Service Bulletin No. TR20060208
Subject: Valve Cover Replacement
Model: HHN34TVDTCSL4 & 5
Product Group: Ride-on Trowels
Date: 02-08-06

Rocker Cover Replacement

HHN34TVDTCSL4 & HHN34TVDTCSL5 Valve Cover Replacement

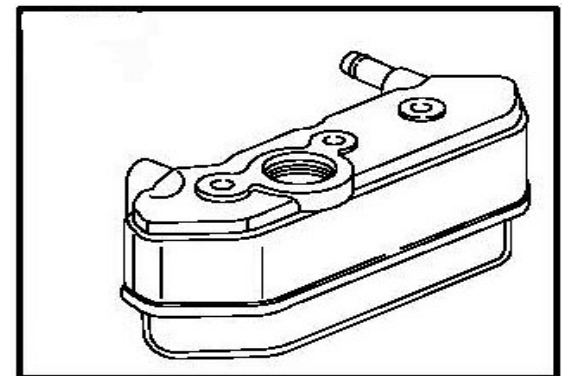
Multiquip has discovered that if the crankcase is overfilled and certain maneuvers are performed with the HHN34TVDTCSL4 and HHN34TVDTCSL5, engine damage may result. To eliminate this possibility, the Valve/Rocker Cover has been updated by shortening the breather channel passage.

Step 6: Remove the Rocker Cover by removing the 3 nuts on the top of the cover. Carefully remove the breather hose from the Rocker Cover.

Step 7: Ensure the new Rocker Cover Gasket is properly seated in the new Rocker Cover. Install the new Rocker Cover using the nuts and washers from the original cover. **Torque nuts to 50 in. lbs.**

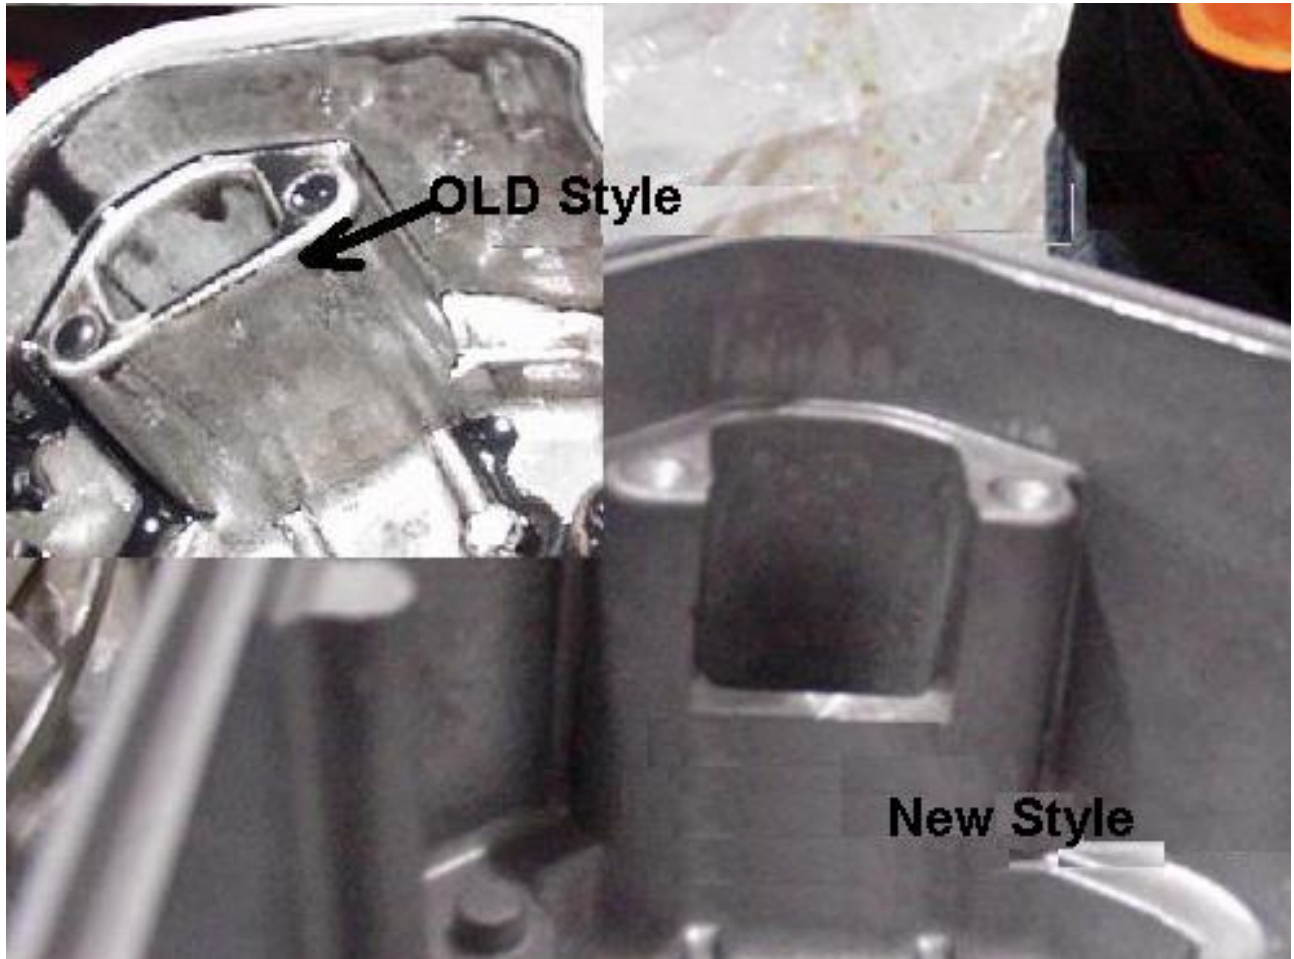
Step 8: Reinstall the Air Intake Pipe to the Turbocharger. **Torque nuts to 115 in. lbs**

Step 9: Reinstall the Air Intake Hose using the original clamps. Attach the Breather Hose to the Rocker Cover inlet.
